This document is a response to the Jamaso (DA-2243-00) second submission comments submitted on October 4th, 2021 by the Office of Development Assistance. Responses are below in **RED**:

Second Submission Review

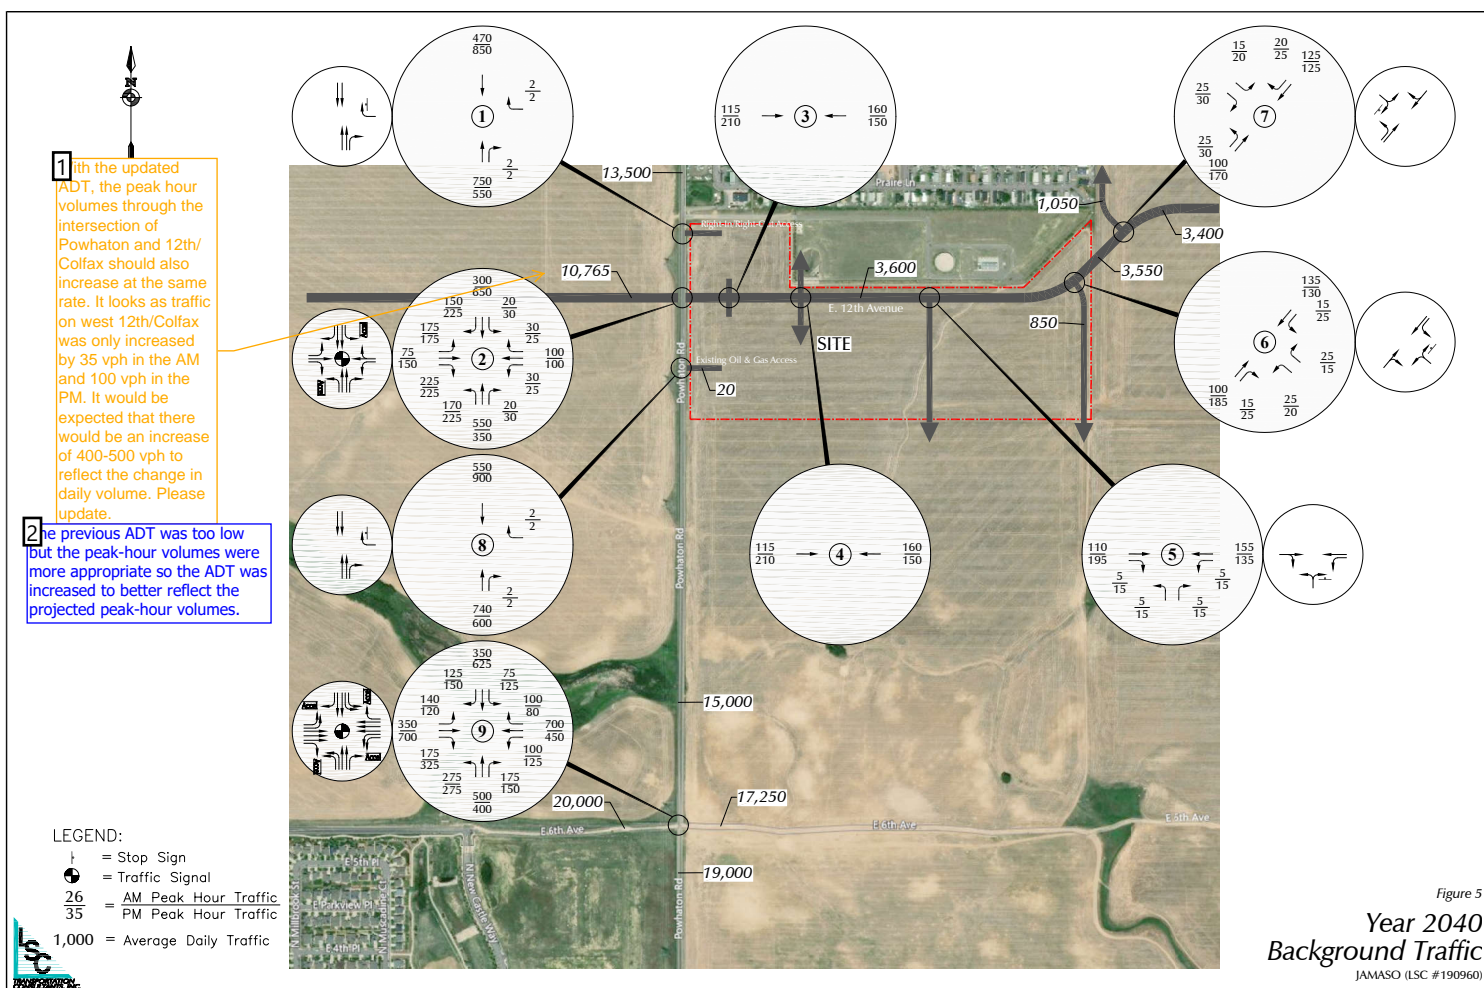
Spacing between accesses and Powhatan are not on this figure per the response to comments, but they are available on the provided land use map.

Spacing has been added

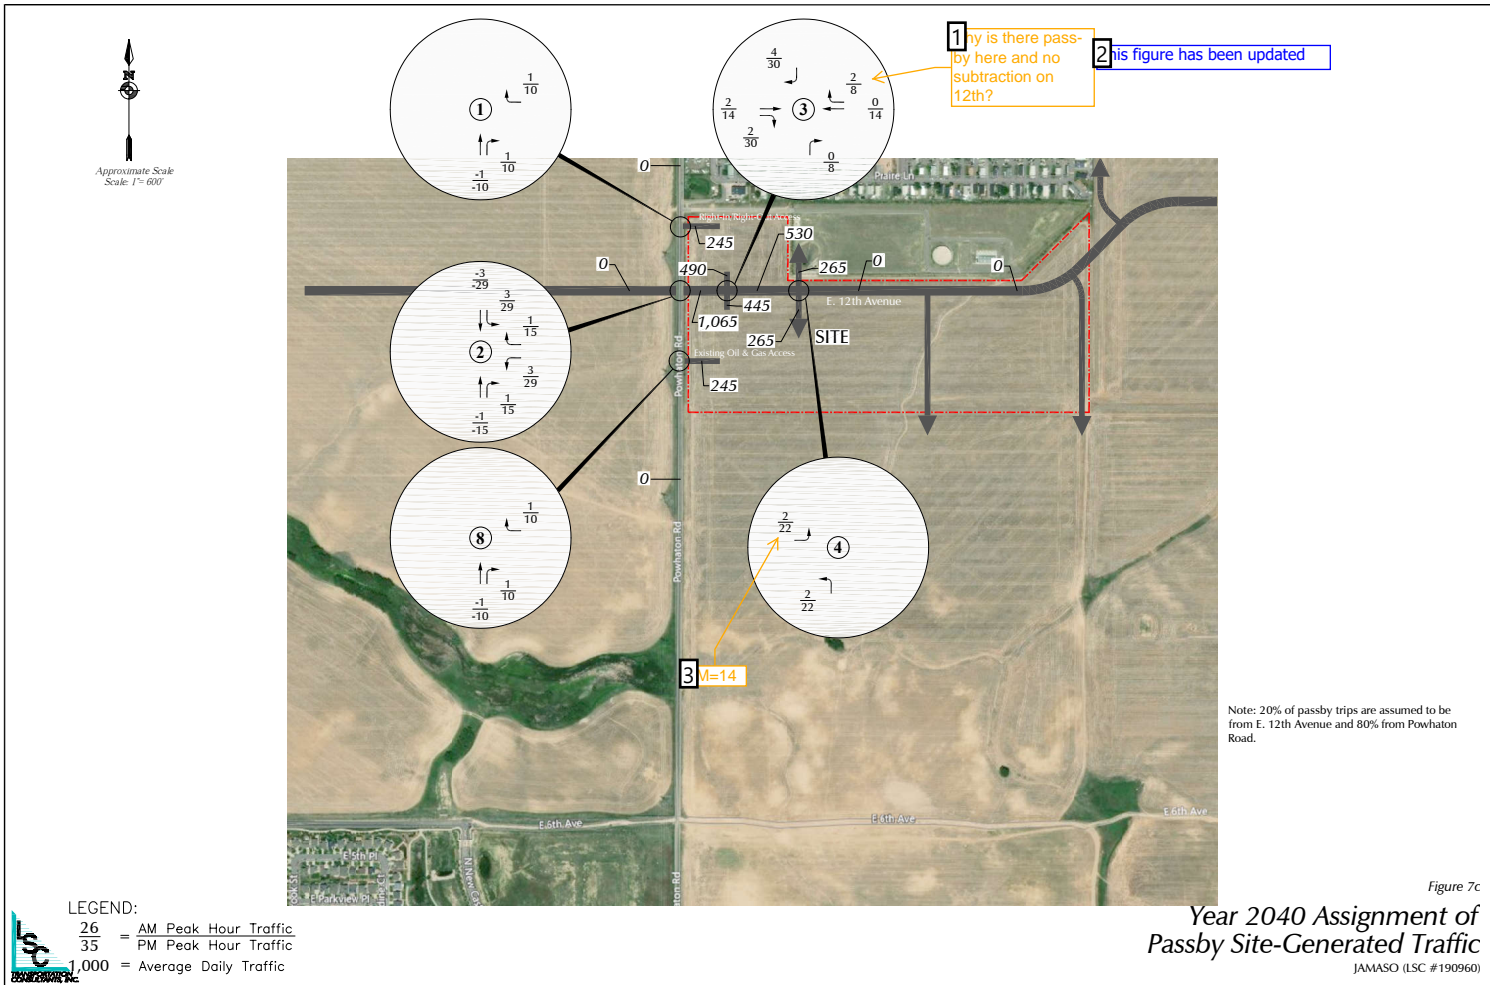
With the updated ADT, the peak hour volumes through the intersection of Powhatan and 12th/Colfax should also increase at the same rate. It looks as traffic on west 12th/Colfax was only increased by 35 vph in the AM and 100 vph in the PM. It would be expected that there would be an increase of 400-500 vph to reflect the change in daily volume. Please update.

The previous ADT was too low but the peak-hour volumes were more appropriate so the ADT was increased to better reflect the projected peak-hour volumes.

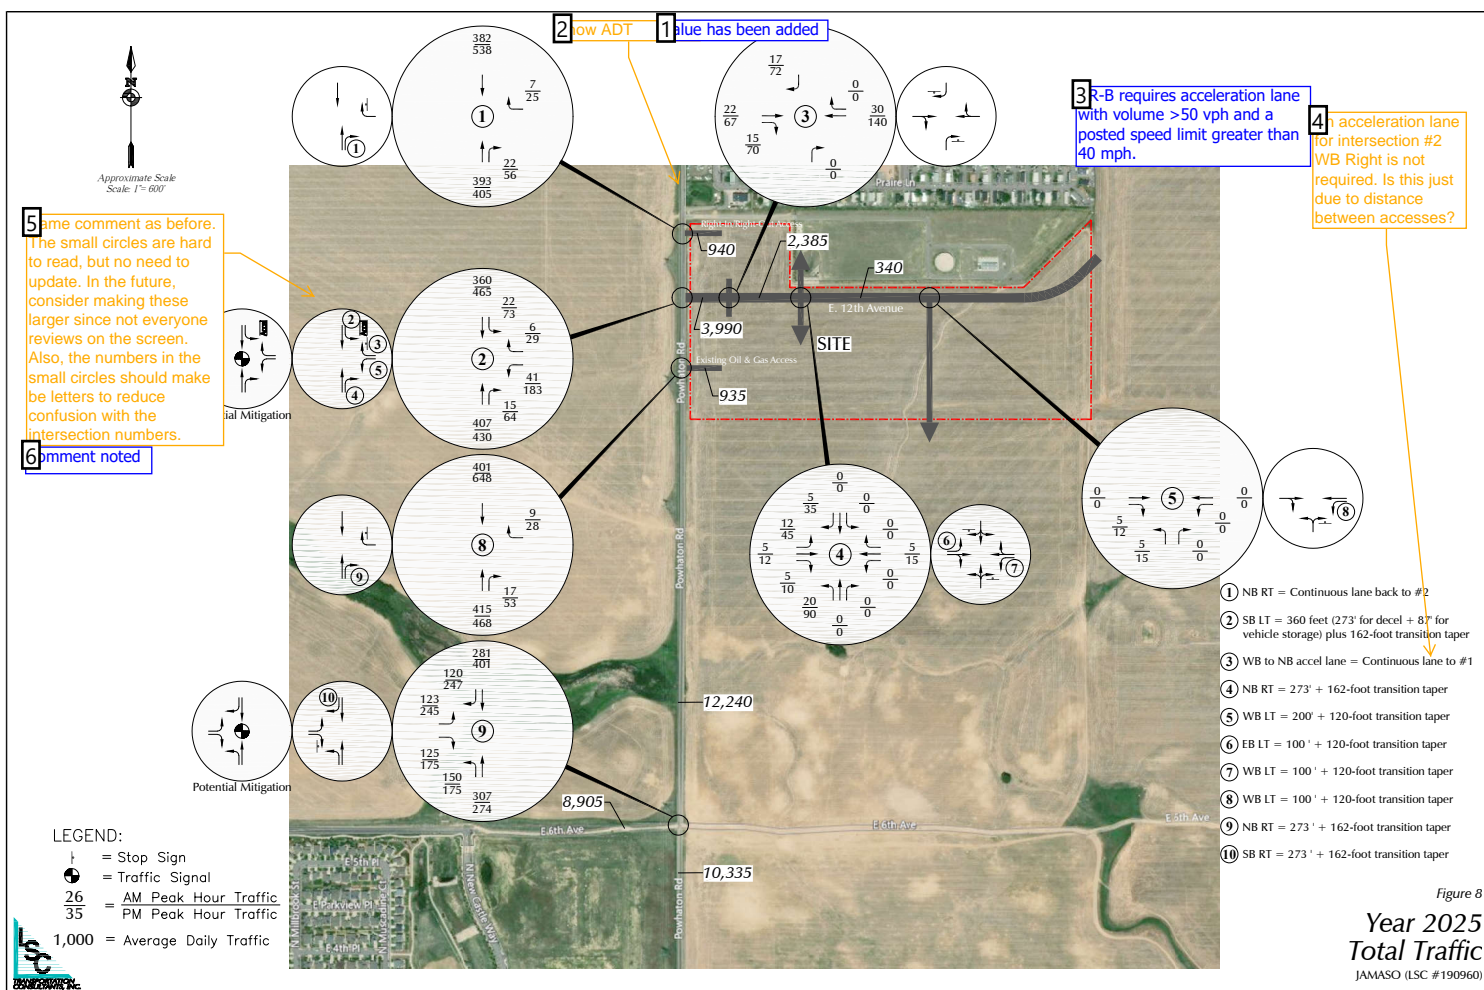
why is there pass-by here and no subtraction on 12th?

Figure 9
**Year 2040
 Total Traffic**
 JAMASO (LSC #190960)

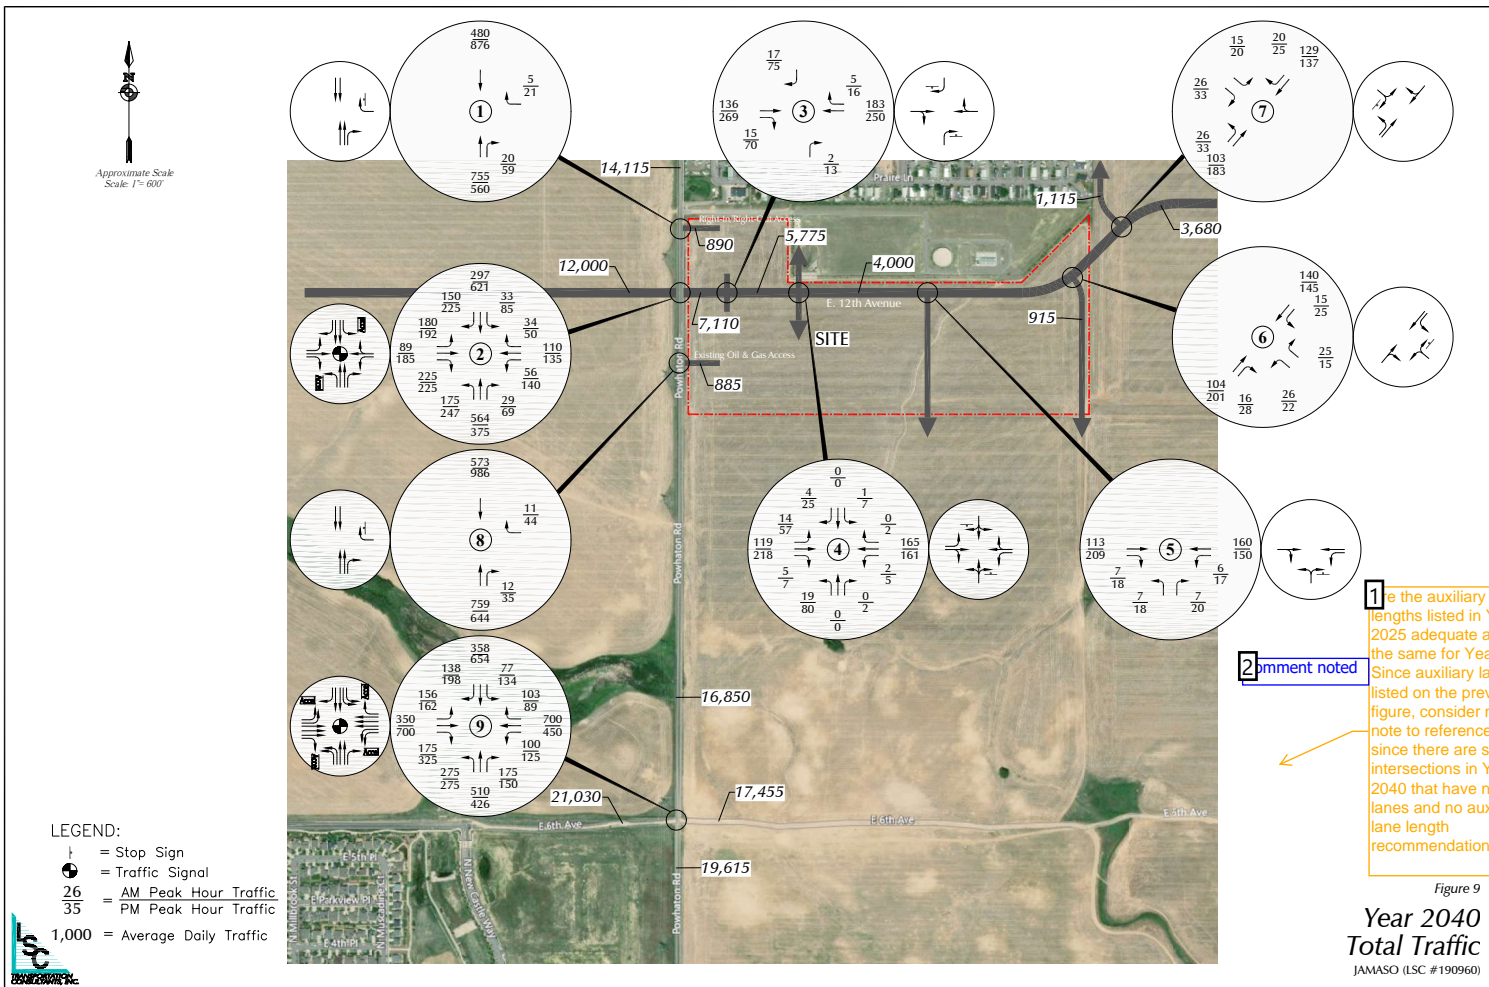
1. The E. 12th Ave. is proposing to extend into the parcel north of the site, located in the County (Figure 9 of the Traffic Impact Study). Is this the conceptual roadway design per an agreement? Has there been coordination with the property owners about this roadway alignment?

ILC Response: The Team met with the County on November 8, 2021 to discuss the conceptual alignment. The conceptual roadway has not been coordinated with the adjacent property owners nor is it in an agreement. The Team showed the roadway to the north offsite, as the half-section collector may not continue north through the Aurora Prairie Waters to the Foxridge Farm mobile home park. The County may make its own considerations as to road connectivity in unincorporated areas.

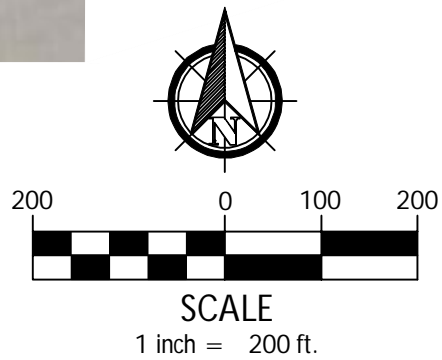
What is this serving?

A waterline connection here may help reduce the amount of waterline needed.

Due to the locations of the Fire Hydrants, this is not a beneficial revision.
